PROJECT:  
ADDITIONS & ALTERATIONS FOR:  
**THE MARRON RESIDENCE**

**Re: 39 Barberie Avenue—Christopher Marron  
Block 76, Lot 15  
R-2.01 Zone  
First Engineering Review**

1. Land Use Board Application.
2. Zoning denial letter, dated January 26, 2021.
3. One (1) set of Architectural Plans prepared by Minkler Architecture & Design, dated November 29, 2020, consisting of three (3) sheets.

NOTE:  
THE ADJACENT DRAWING IS A REPRODUCTION OF AN  
ORIGINAL SURVEY TAKEN BY 'SENECA SURVEYING  
CO., INC.' DRAWING DATED 2015-12-16. ORIGINAL  
SURVEY SHOWN FADED TO CALL ATTENTION TO ANY  
MARK-UPS BY THIS OFFICE.

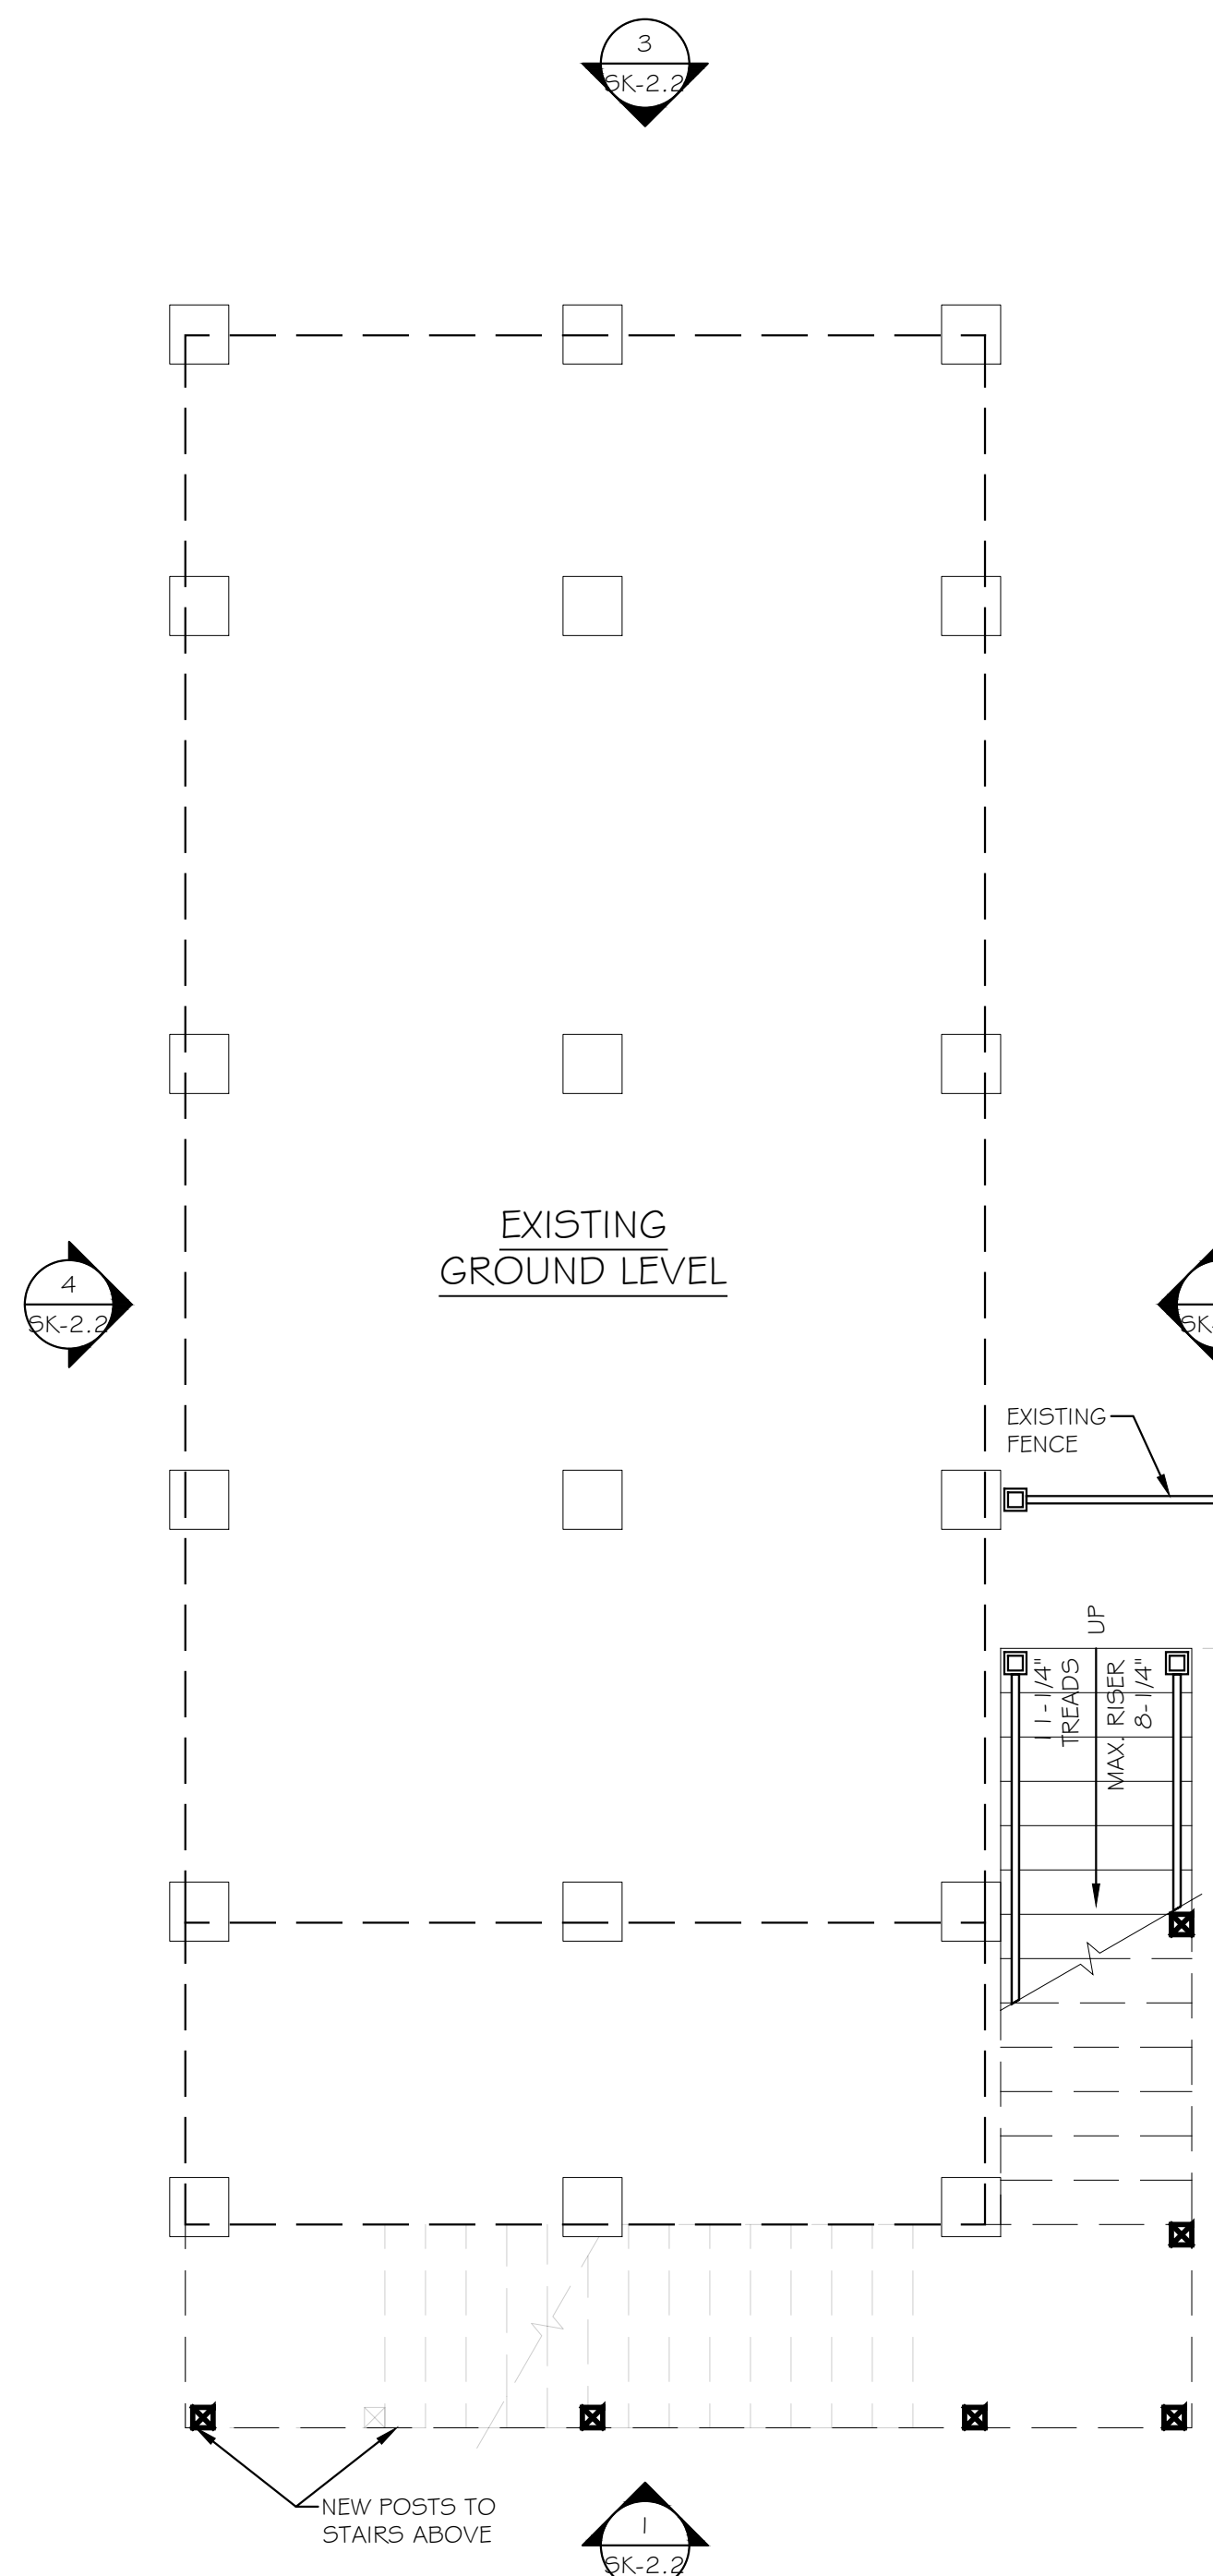
1. It is noted that the survey referenced is from 2015 and does not accurately depict some site features such as the concrete driveway and pvc fence.
2. The applicant shall confirm that the existing concrete driveway complies with Ordinance section 21-65.5 for maximum width of 18' at the curb and 22' on the lot.

**1 PROPOSED GROUND LEVEL PLAN**  
SCALE: 1/4" = 1'-0"

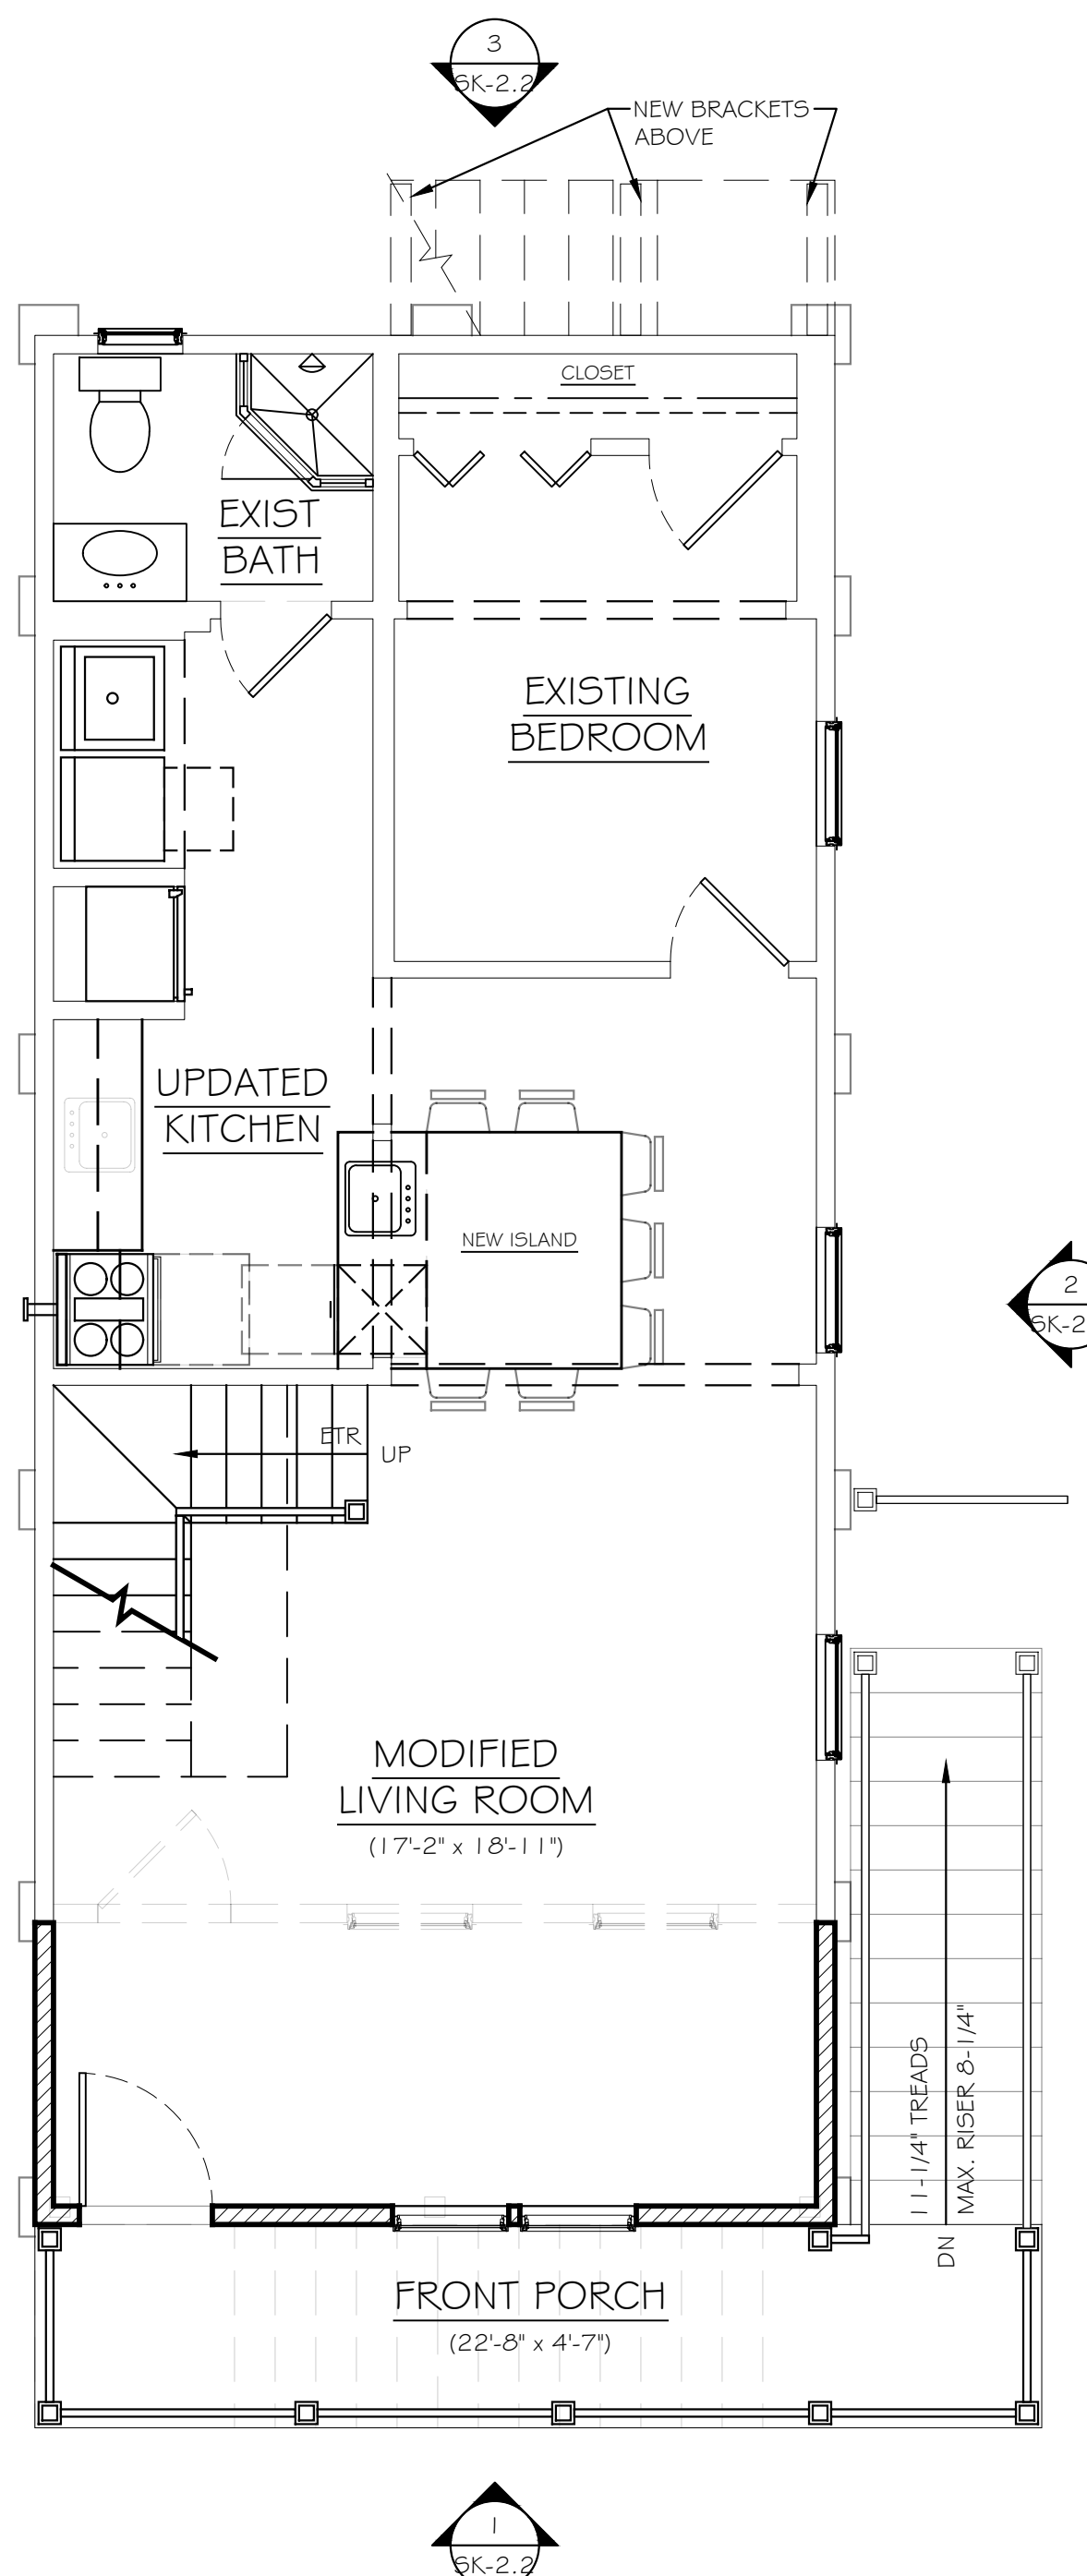
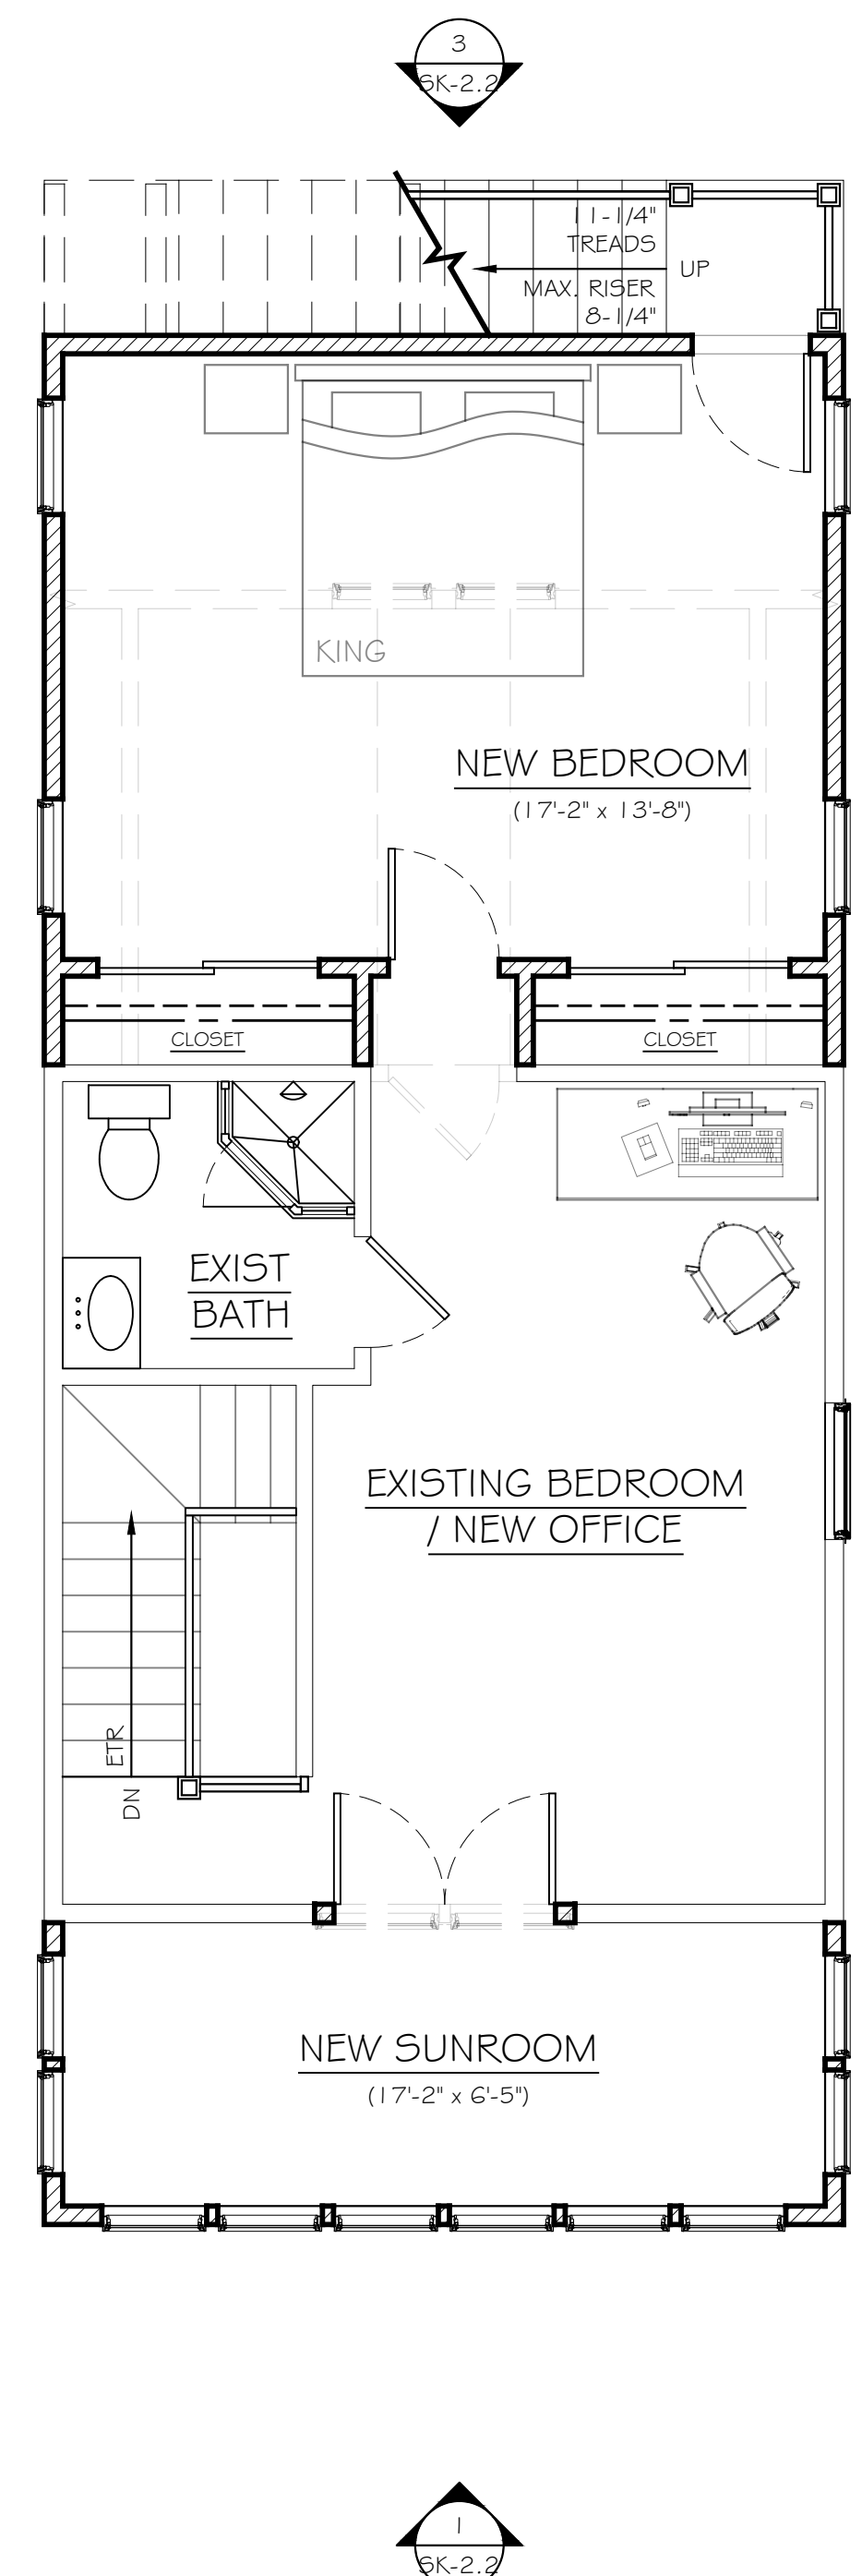
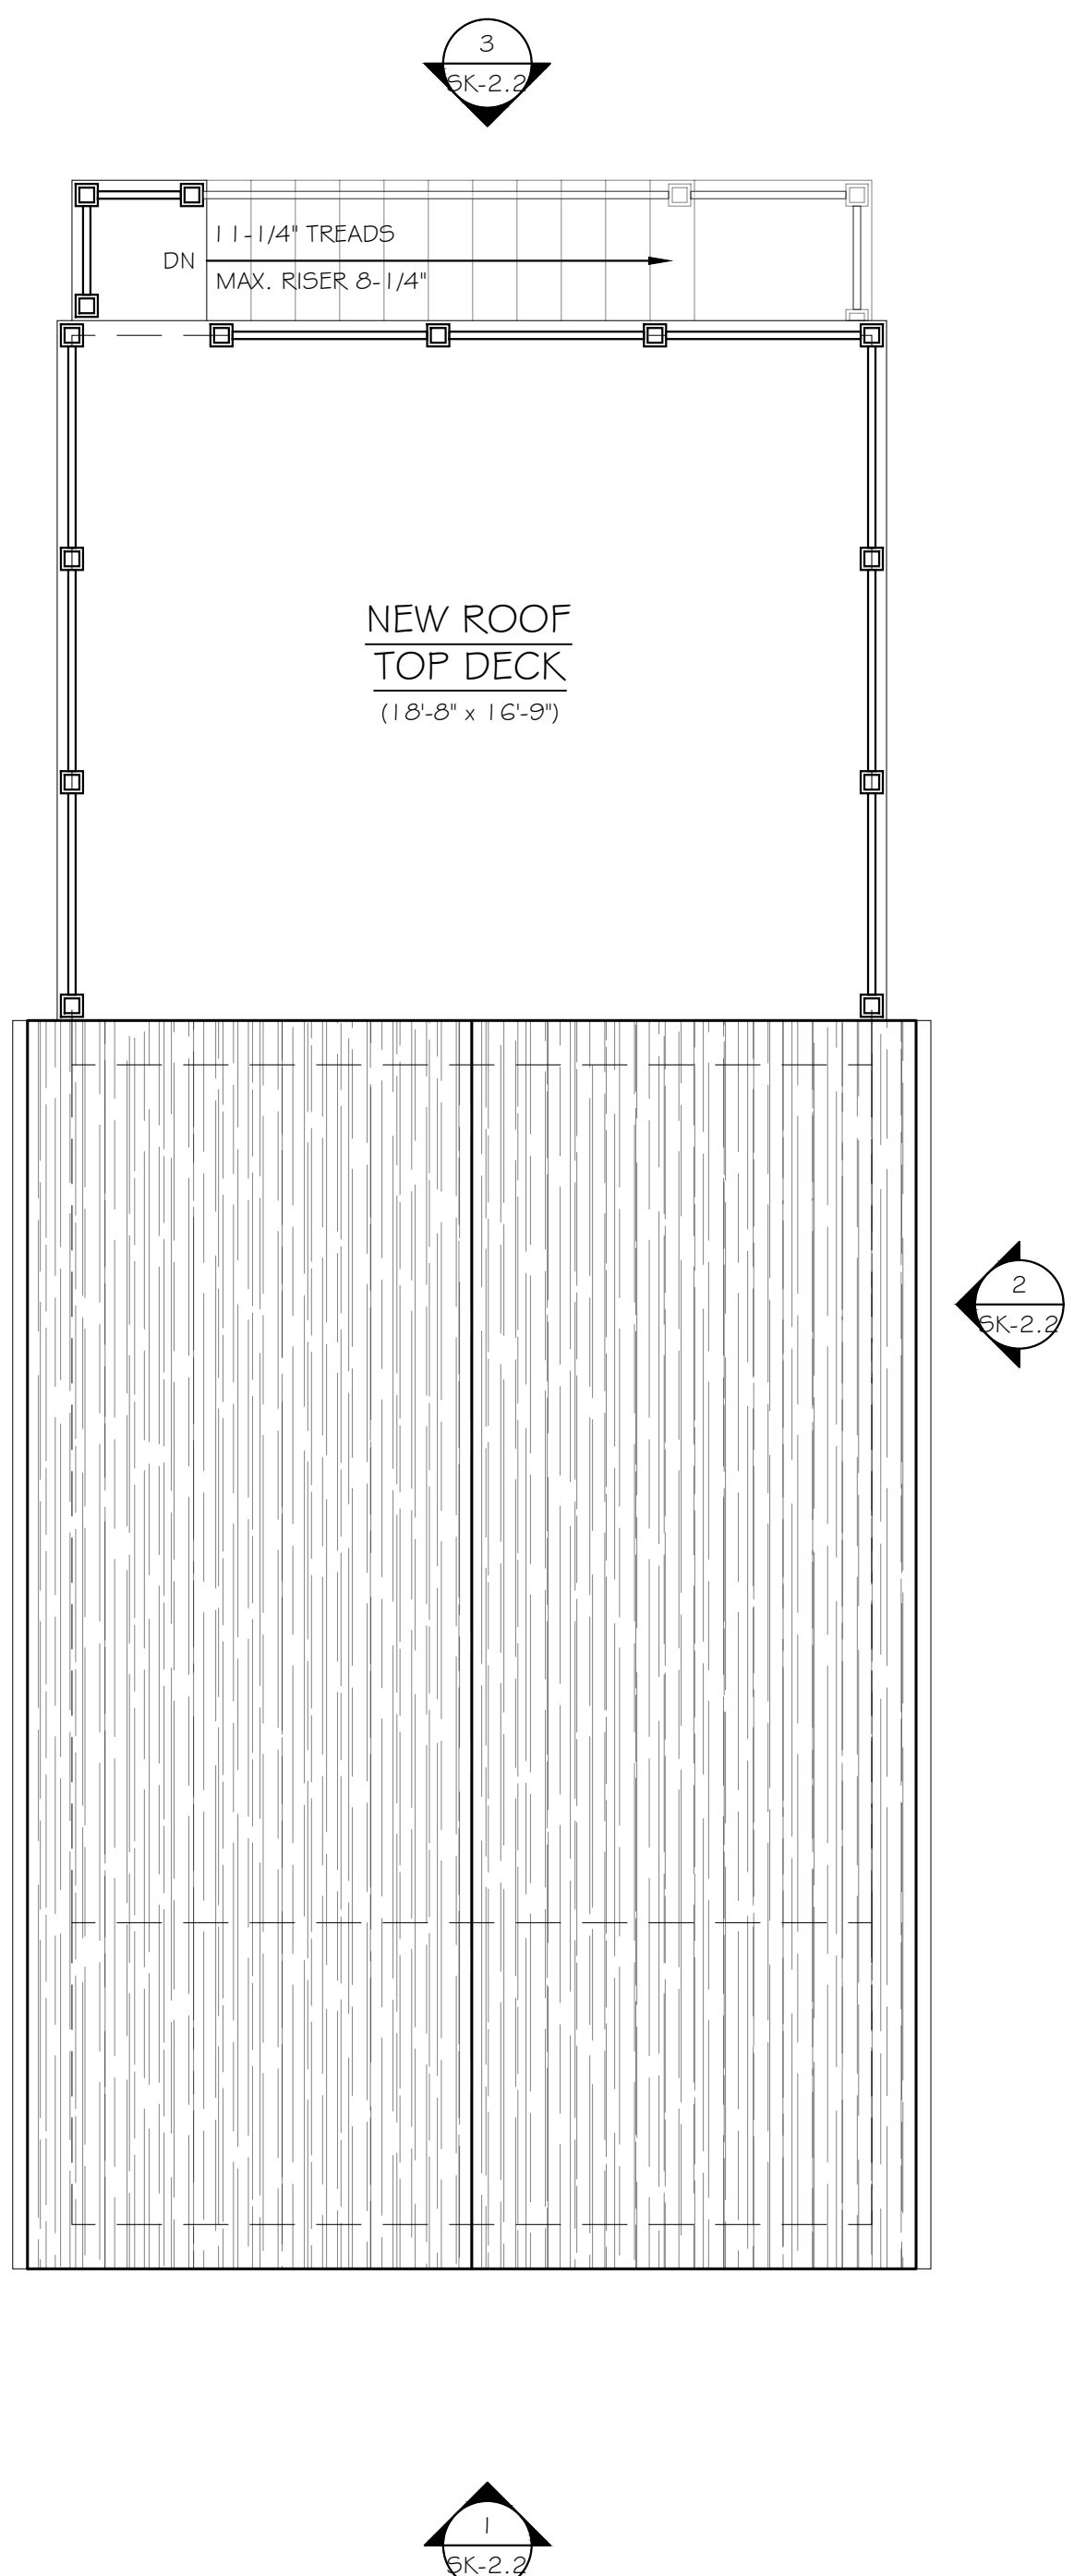
18. Preliminary architectural plans for the proposed buildings or structures indicating typical floor plans, elevations, heights and general design or architectural styling. **Partially Provided. Since the proposed structure is located within the VE Zone, plans should be revised to include details regarding the materials to be used for the foundation walls and compliance with V zone construction requirements.**
